Subject: MHI's Responses to US-APWR DCD RAI No.40

Responses to Request for Additional Information No.40 Revision 0

US-APWR Design Certification

RAI NO.: NO.40-610 REVISION 0
SRP SECTION: 19 – Probabilistic Risk Assessment and Severe Accident Evaluation
APPLICATION SECTION: PRA
DATE OF RAI ISSUE: 7/29/2008

Figure 19-99.1 Containment spray function

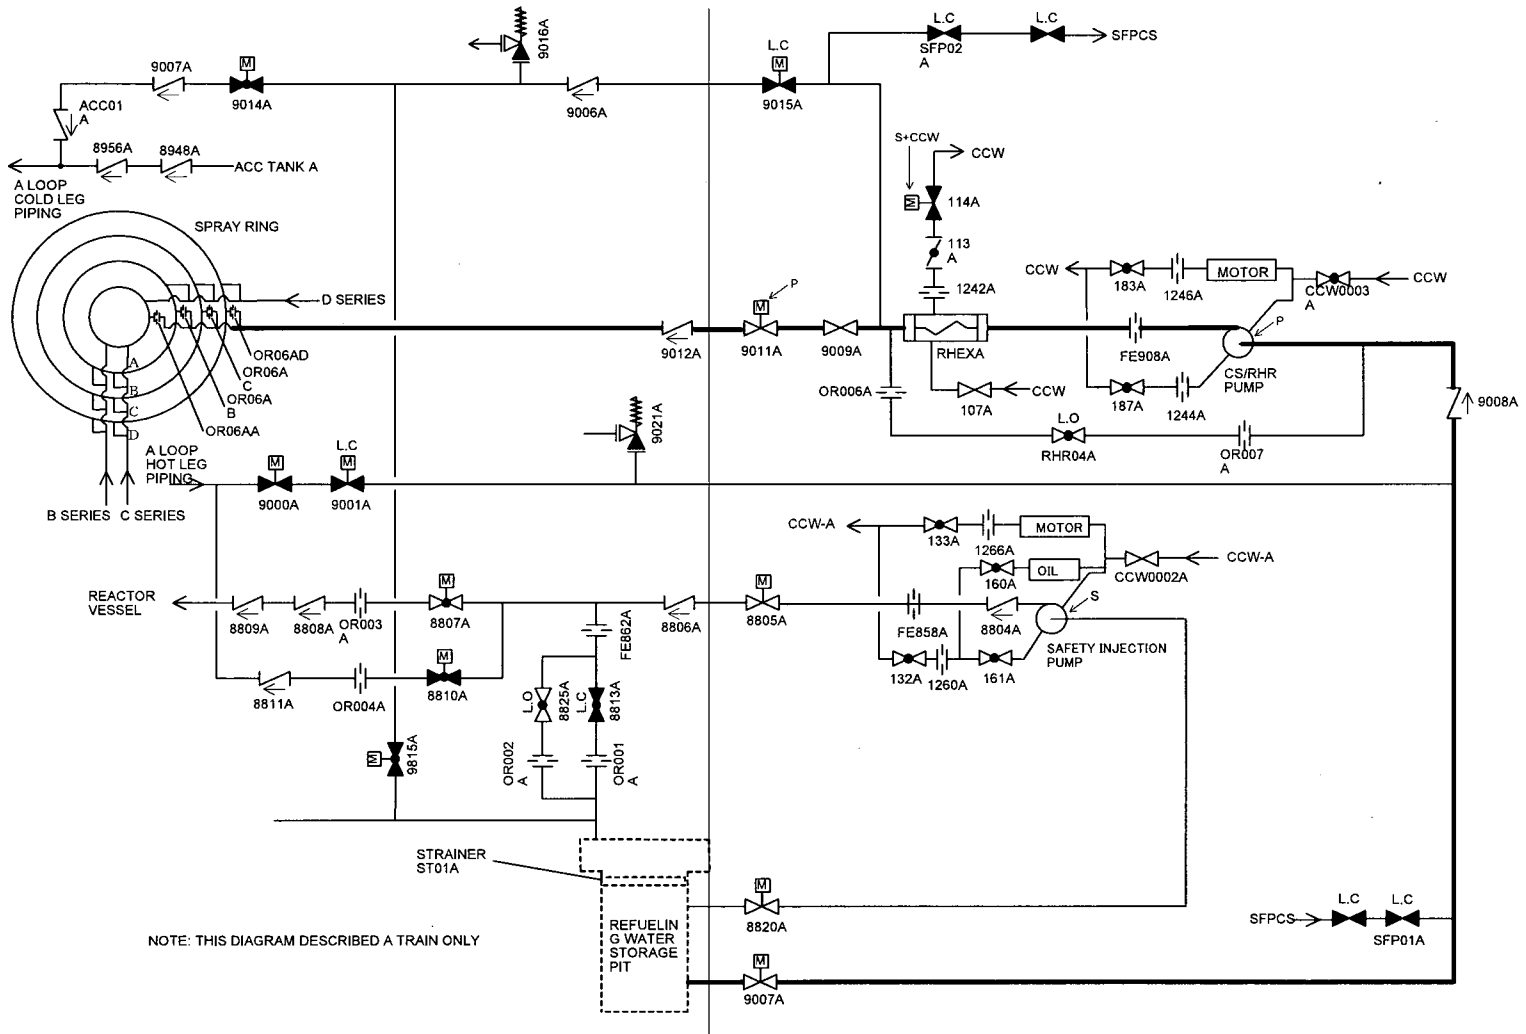
Several event trees (e.g., MLOCA, SLOCA and SGTR) assume that containment heat removal by the CS/RHR system is possible (e.g. top event CXC in the MLOCA event tree) given failure of containment spray injection by the CS/RHR system (e.g., top event CSA in the MLOCA event tree). Based on the definitions of top events CSA and CXC (Section 3.2.2.2 of the PRA report), it appears that the only difference between these two top events is that CXC requires operation of the CS/RHR heat exchangers while CSA does not. If this is correct, CXC cannot succeed when CSA fails. However, a branch is shown in the event tree indicating that CXC can succeed even when CSA fails. Please explain.

- 1) CS/RHR (containment spray, CSA): failure of spray injection function is modeled as described in Figure 19-99.1.
- 2) CS/RHR (Alternate core cooling, CRD): failure of cold-leg injection function including failure of re-lineup operation is modeled as described in Figure 19-99.2.
- 3) CS/RHR (Heat removal, CXC): failure of cooling heat exchangers by opening MOV-114 (isolation valves of CCW) is modeled.

Because fault tree linking methods are applied for each sequence analysis, CXC is unable to function when CSA fails, e.g. CS/RHR pumps fails described in Figure 19-99.1, as you pointed out.

However, CXC sometimes succeeds even when CSA fails, e.g. MOV-9011 described in Figure 19-99.1 fails to open. Event trees represent possible branches for which dependent failure probabilities are quantified by fault tree linking methods considering these interactions.
